PROJECT:	Wells County Public Library Renovations	SUPPLEMENTAL INFORMATION (SI) NUMBER:	16.1
		DATE OF ISSUE:	4/6/2020
OWNER:	WCPL	CONTRACT FOR:	General Construction
		CONTRACT DATED:	12/9/2019
TO CONTRACTOR:	CME Corporation	ARCHITECT'S PROJECT NUMBER:	19067

SUMMARY: New Lighting and Ceiling in 103, 155 and 159
DESCRIPTION:

ENGINEER'S SUPPLEMENTAL INSTRUCTIONS #12 R1
Wells County Public Library Renovation
200 West Washington Street
Bluffton, IN 46714
Commission No. 192414

Prime Contract Potential Change Order #037: CE #070 - SI-16.1 - New Lighting & Diffusers

FIRST FLOOR ELECTRICAL DEMOLITION PLAN

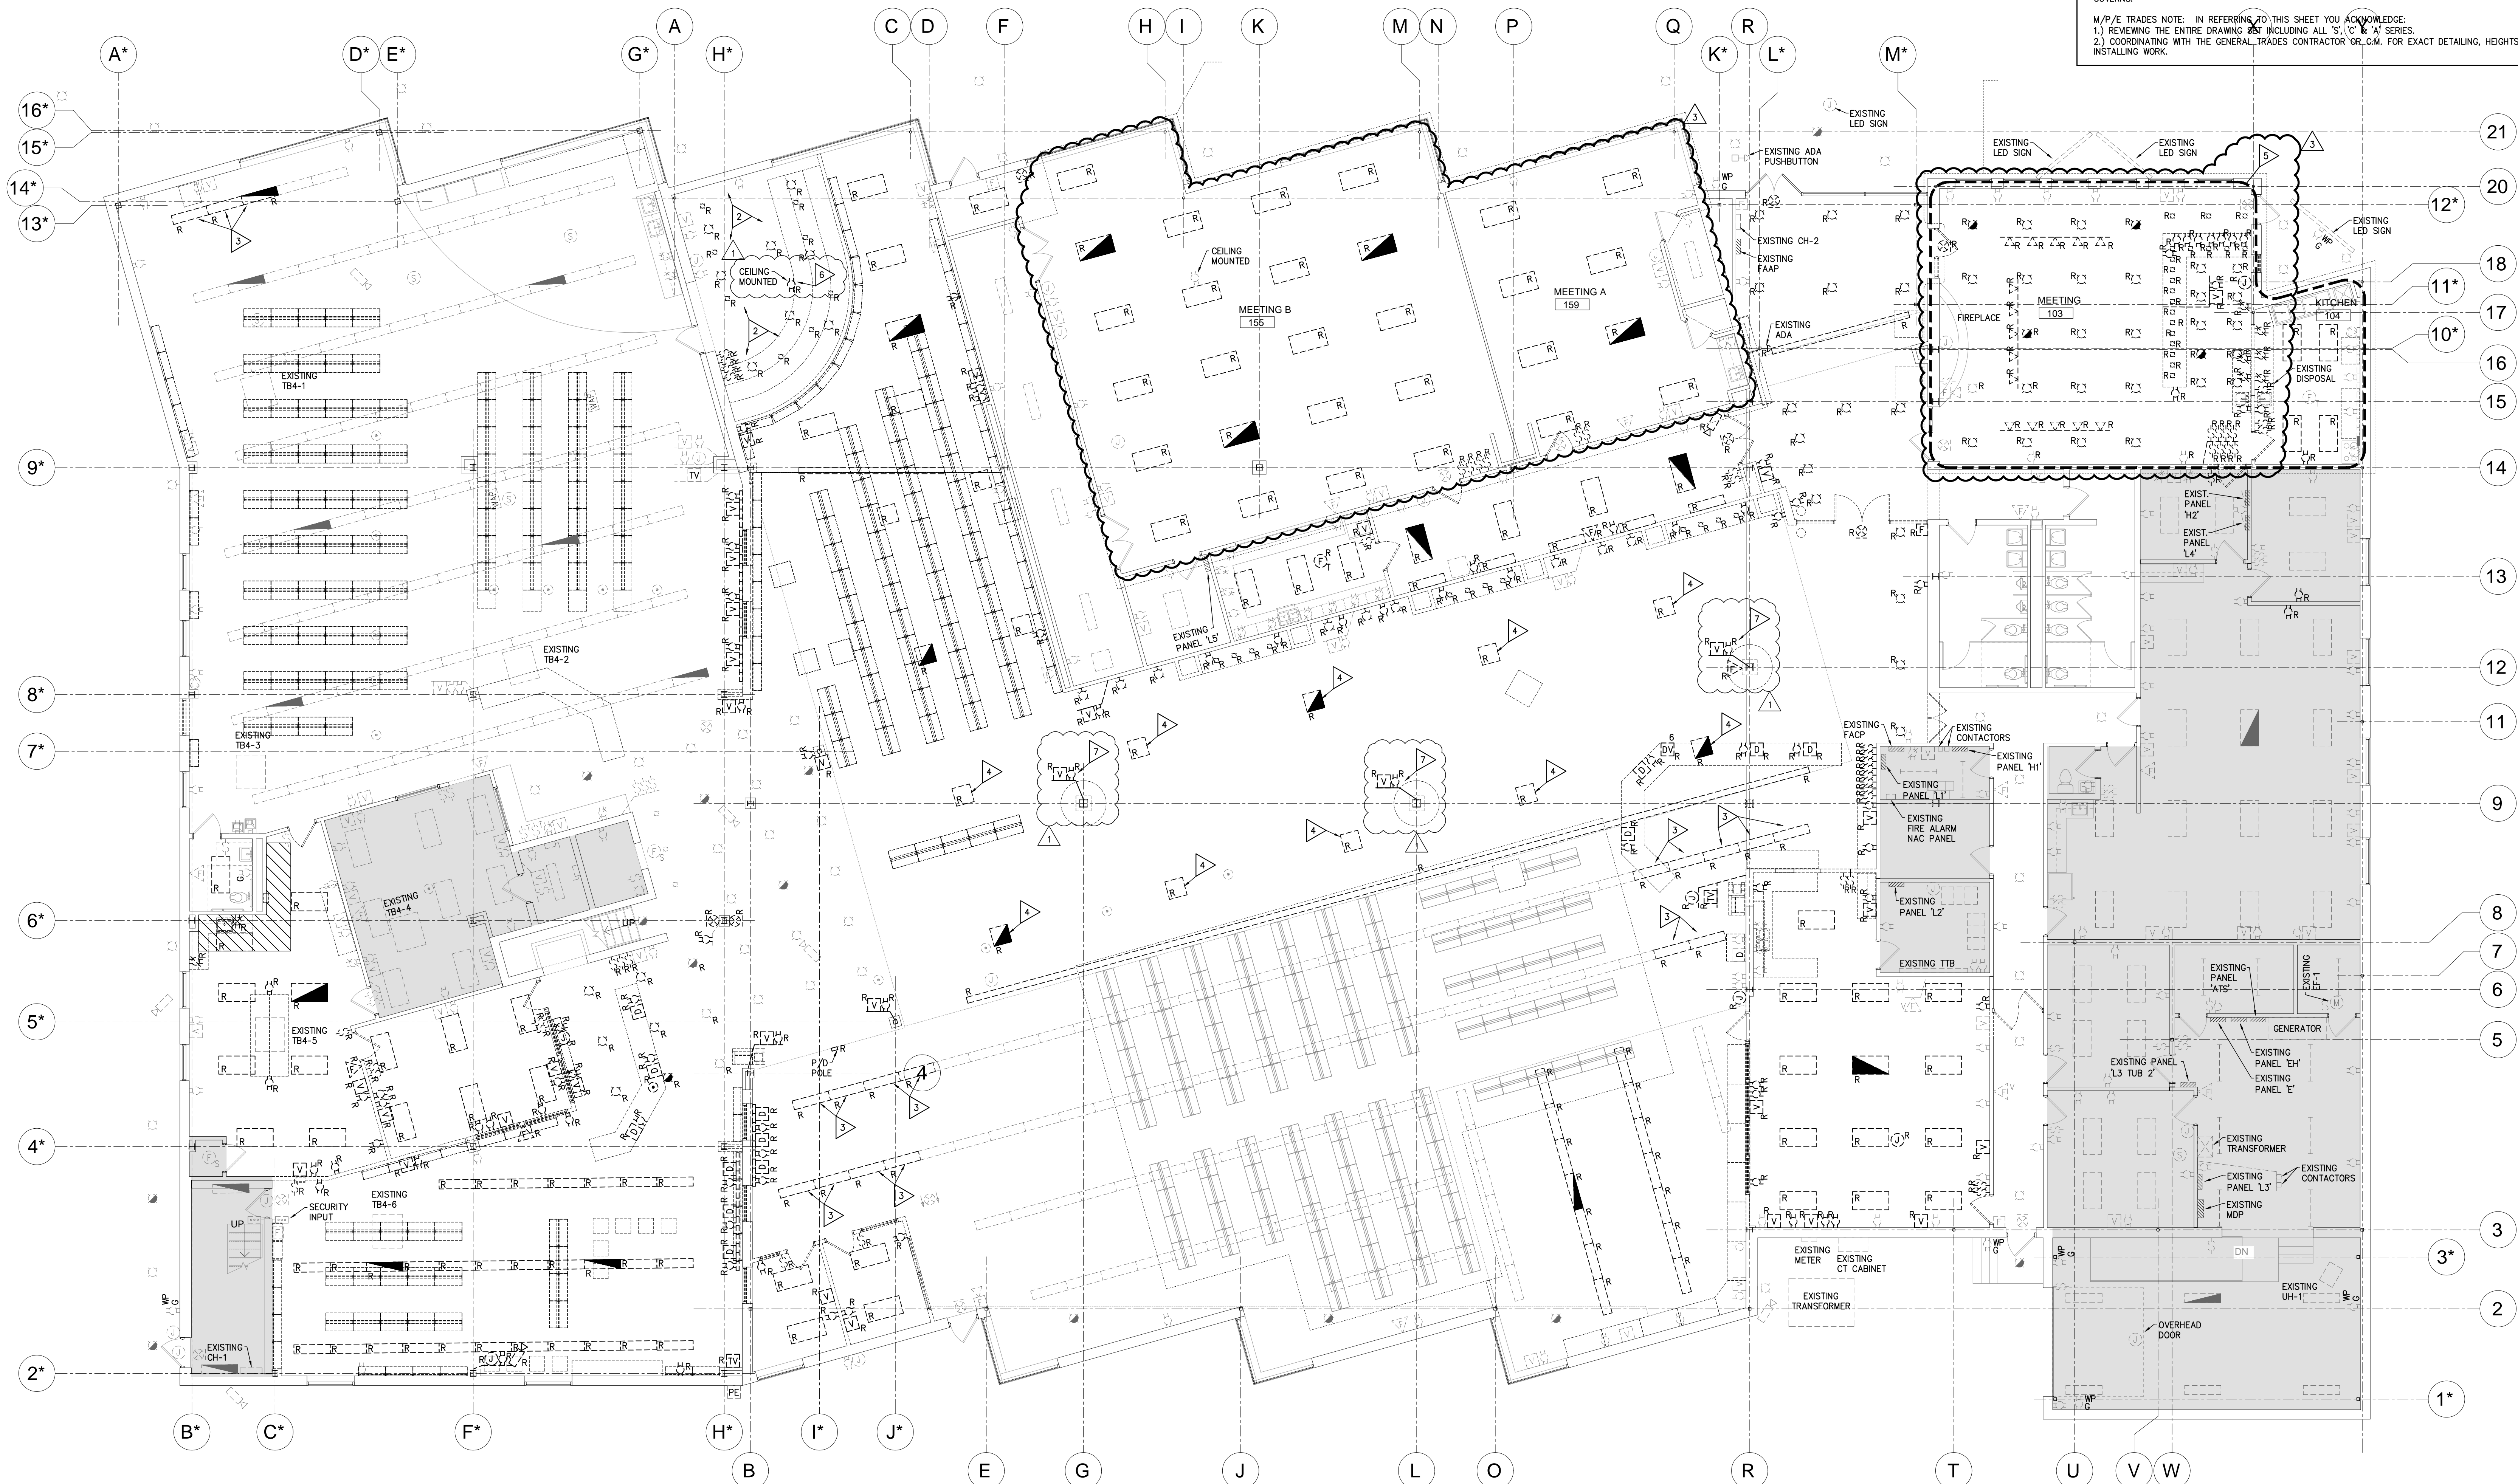
- Item No. 1:** On sheet E-001, the electrical contractor shall state the cost for the demolition of lighting in Meeting #103, Meeting A # 159, and Meeting B #155, as shown on attached Supplemental Information Drawing 2414E001-03-25-2020-SI-16.

EXISTING ELECTRICAL DEVICES BEING REMOVED IN EXISTING WALLS TO REMAIN SHALL HAVE ALL ASSOCIATED CONDUIT / CONDUCTORS REMOVED BACK TO RESPECTIVE PANELBOARD. ELECTRICAL CONTRACTOR SHALL COORDINATE WITH GENERAL CONTRACTOR FOR PATCHING OF WALL TO MATCH ADJACENT SURFACES, TYPICAL.

1	DISCONNECT MECHANICAL EQUIPMENT FOR REMOVAL BY MECHANICAL CONTRACTOR, ASSOCIATED CONDUIT AND CONDUCTORS SHALL BE REMOVED IN THEIR ENTIRETY TO POINT OF ORIGINATION.
2	ELECTRICAL CONTRACTOR SHALL DISCONNECT AND REMOVE EXISTING FIBER OPTIC LIGHTING SYSTEM IN THIS AREA.
3	ELECTRICAL CONTRACTOR SHALL DISCONNECT LENGTH OF SECTIONS SHOWN. CONTRACTOR SHALL KEEP END CAP OF TUBES RUN FOR REINSTALLATION. REFER TO SHEET E-201 FOR ADDITIONAL INFORMATION.
4	ELECTRICAL CONTRACTOR SHALL REMOVE REMOTE BALLASTS ASSOCIATED WITH MAIN LOBBY PENDENT LIGHTING LOCATED ON THE MEZZANINE CATWALK. CONTRACTOR SHALL REMOVE ALL CONDUIT AND CONDUCTORS BACK TO THE POINT OF ORIGINATION.
5	BASE BID: NO WORK IN THIS AREA.
6	ALTERNATE BID: CONTRACTOR SHALL DEMOLISH ELECTRICAL DEVICES AS SHOWN. PREPARE EXISTING CONDUCTORS FOR NEW WORK AS NECESSARY.
7	CONTRACTOR SHALL DISCONNECT AND REMOVE CEILING MOUNTED RECEPTACLE AND REMOVE CONDUCTORS BACK TO EXISTING JUNCTION BOX ABOVE CEILING AND PREPARE CONDUCTORS FOR NEW WORK.

8	ELECTRICAL CONTRACTOR SHALL DISCONNECT AND REMOVE EXISTING RECEPTABLES AND PREPARE CONDUCTORS AND JUNCTION BOX FOR NEW WORK.

E-201

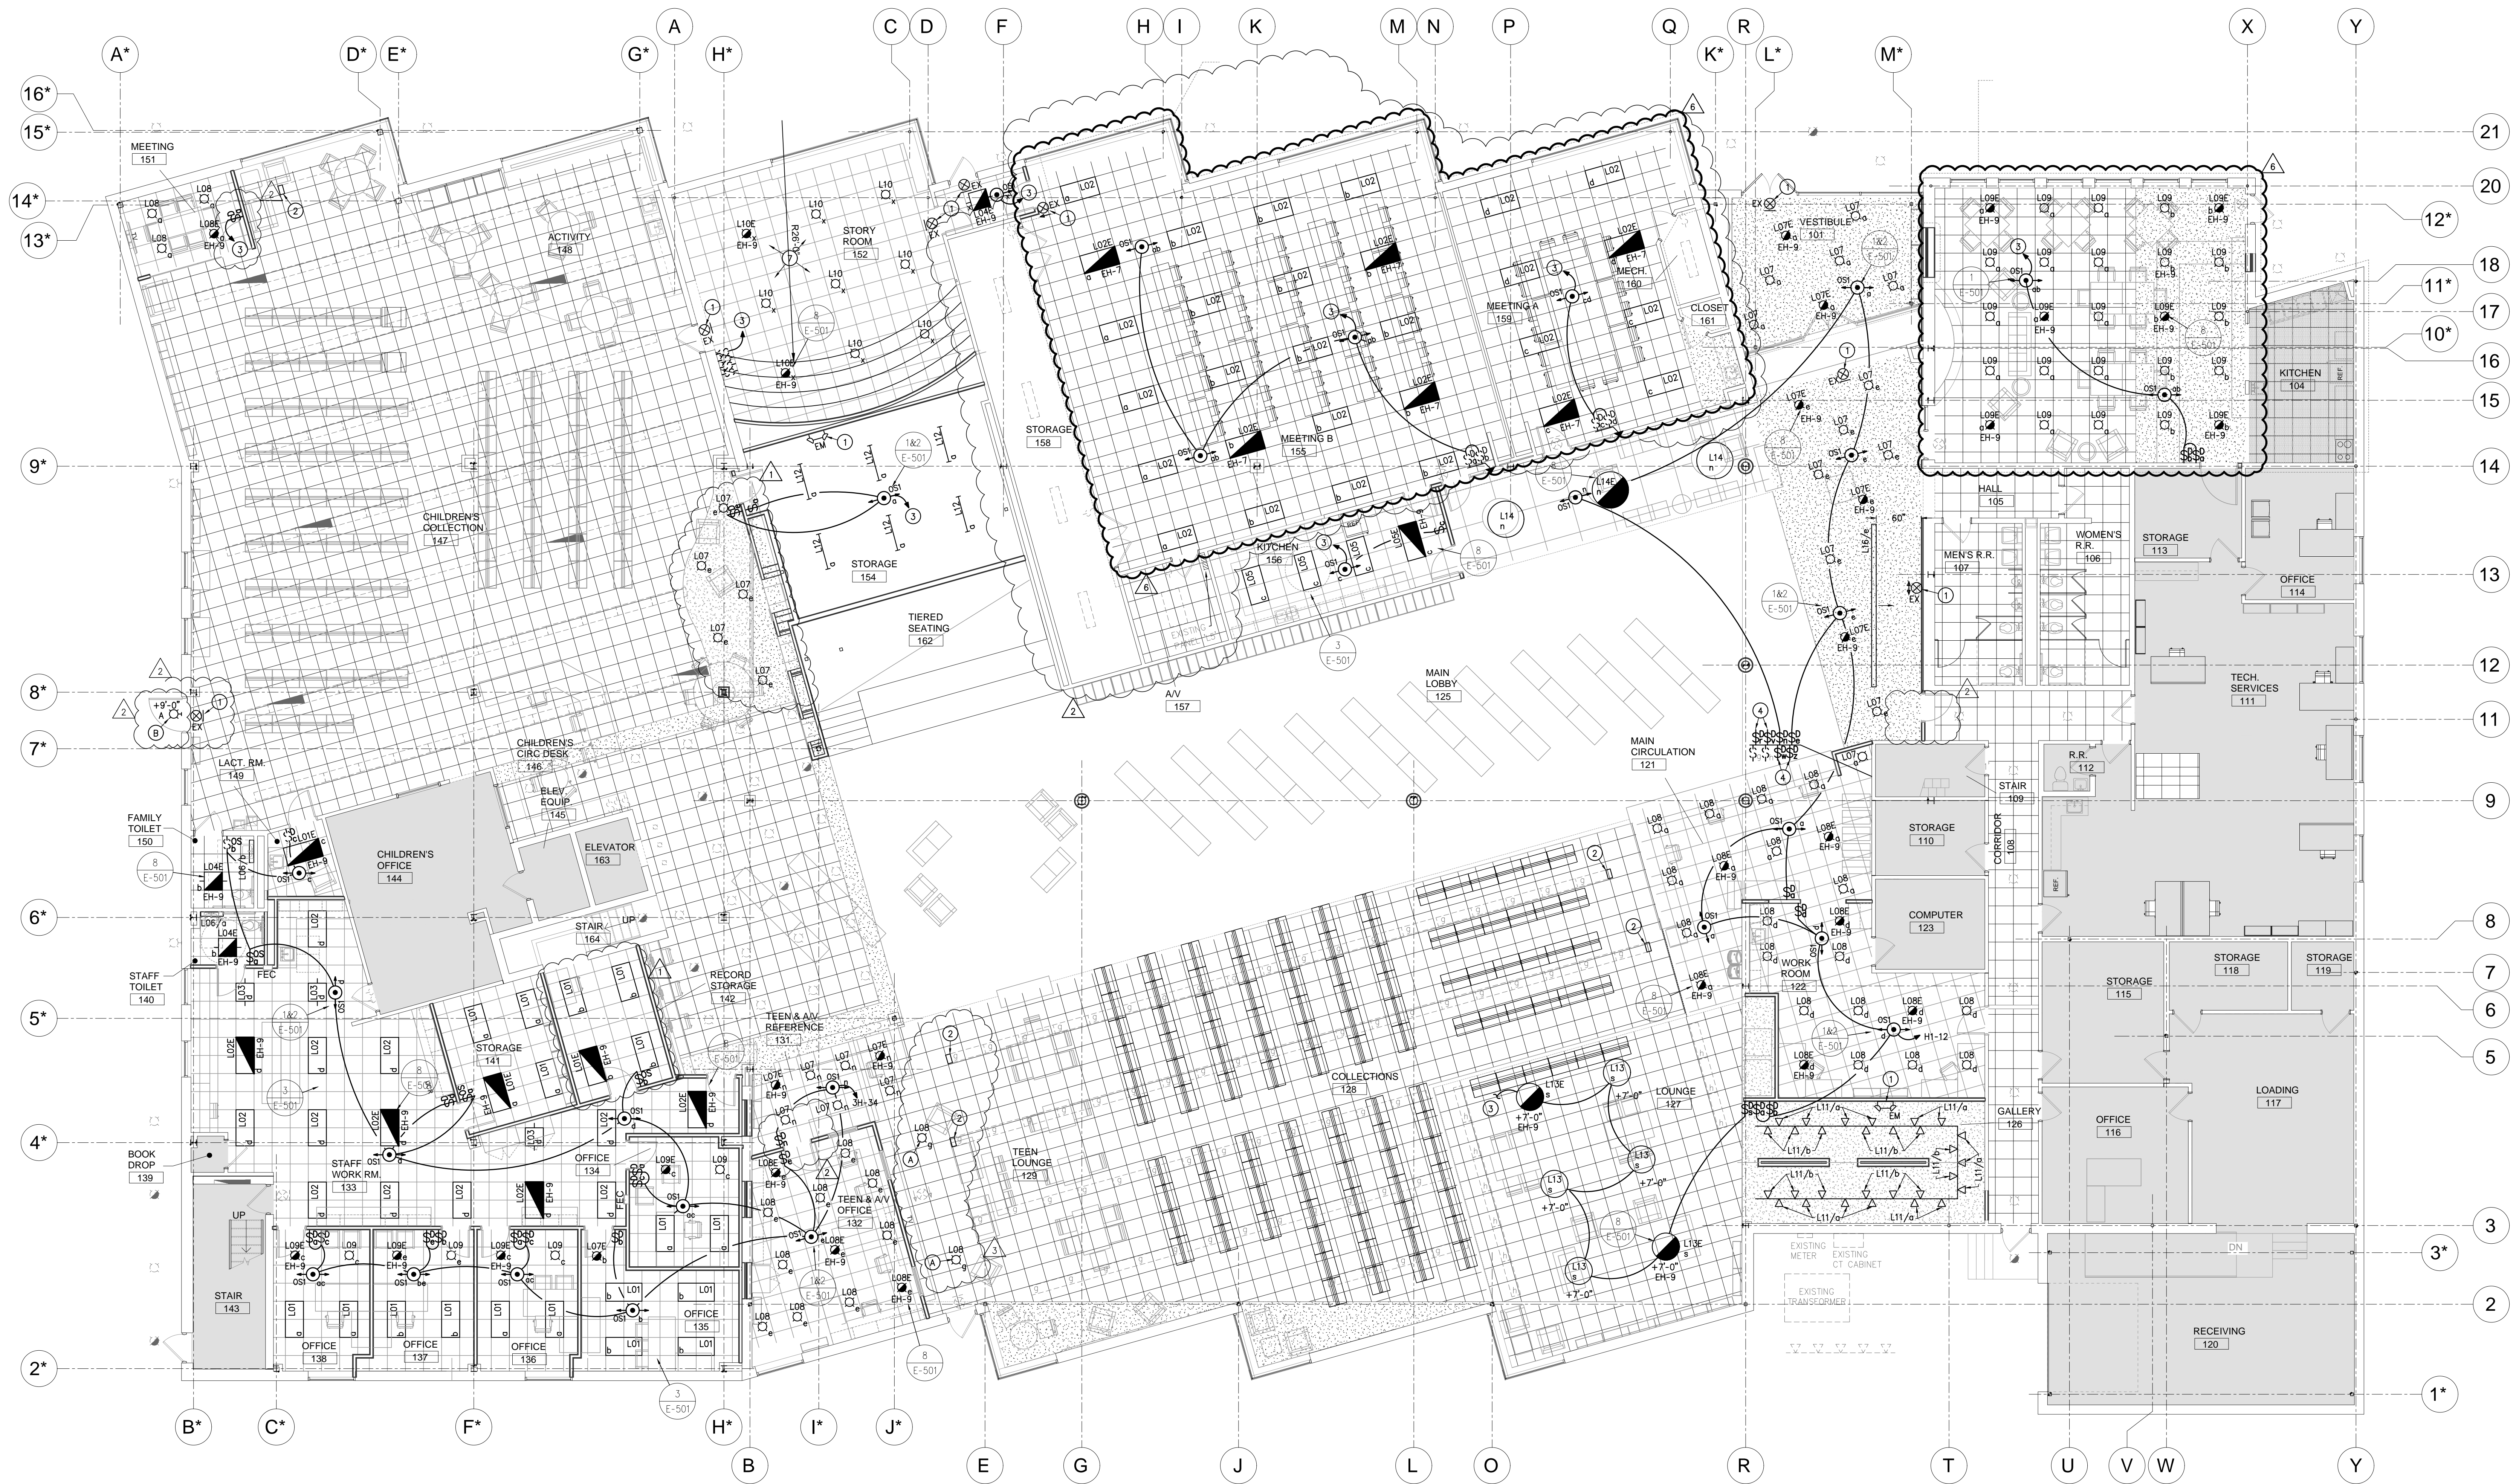
- Item No. 2:** On sheet E-201, the electrical contractor shall state the cost for the addition of new fixtures as specified in Meeting #103, Meeting A # 159, and Meeting B #155, 128 as shown on attached Supplemental Information Drawing 2414E201-03-25-2020-SI-16. Contractor provide all hardware, accessories, conduit, and conductors for a complete and code compliant system.

- 1 ELECTRICAL CONTRACTOR EXTEND CONDUIT AND CONDUCTORS AS REQUIRED TO TERMINATE EMERGENCY LIGHTING AND ESIS TO EMERGENCY GENERATOR EXISTING CIRCUIT "H-9". CONTRACTOR SHALL PROVIDE ALL HARDWARE AND ACCESSORIES TO PROVIDE A COMPLETE AND FULLY FUNCTIONAL SYSTEM.

- 2 ELECTRICAL CONTRACTOR SHALL RE-INSTALL EXISTING END CAP FROM REMOVED SECTIONS REMOVED ON SHEET E-001. CONTRACTOR SHALL PROVIDE ALL HARDWARE AND ACCESSORIES AS REQUIRED TO SHORTEN EXISTING FIXTURE TO THE LENGTH SHOWN. CONTRACTOR SHALL REPAIR EXISTING FIXTURE(S) TO MATCH EXISTING SECTIONS AS REQUIRED. CONTRACTOR SHALL ENSURE THAT THE EXISTING FIXTURES ARE COMPLETE AND FULLY FUNCTIONAL.

- 3 ELECTRICAL CONTRACTOR SHALL EXTEND CONDUIT AND CONDUCTORS AS REQUIRED TO TERMINATE TO EXISTING LIGHTING CIRCUIT SERVING AREA.
- 4 DIMMING LIGHTING CONTROLS ARE TERMINATED TO OCCUPANCY SENSOR AND LIGHTING FIXTURES SHOWN IN MAIN LOBBY #125 ON SHEET E-202.

- **MKM - Please remove the lighting scope changes / costs for Meeting 103. New lighting will remain as shown on original Alternate.**
- **CME - This PCO excludes new lighting in Meeting 103 shown on SI-16.1. New lighting will be provided per current construction documents.**
- **CME - This PCO includes new diffusers in Meeting 103 per SI-16.1 as new diffusers are not provided under the alternate per current construction documents.**
